STAFF SEA CHECKS STAGE IV – INS KULISH (NR-22)

PERFORMANCE TRIALS OF HPAC NO. 1 AND 2 - INS KULISH

5. **Performance trials.**

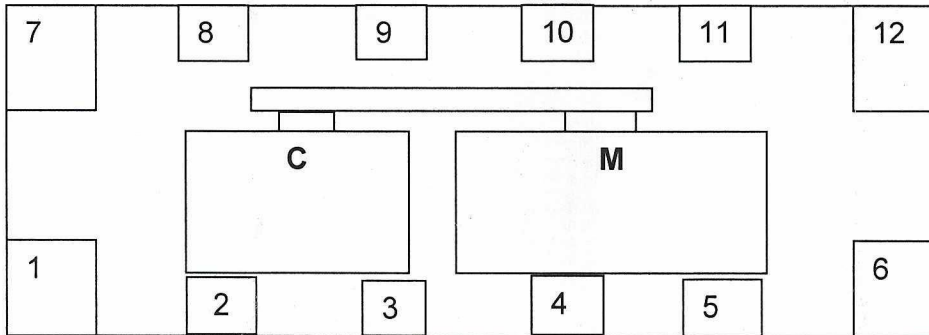
Ser	Description	Unit	HPAC No.1	HPAC No.2
(a)	Compressor starting time	hrs	1511	1524
(b)	Compressor stopping time	hrs	1611	1754
(c)	Time taken	Min	60	150
(d)	Bottle capacity	ltrs	108	258
(e)	Bottle air pressure	Bar	196	205
(f)	Compressor capacity achieved	m ³ /hr	21.16	21.15
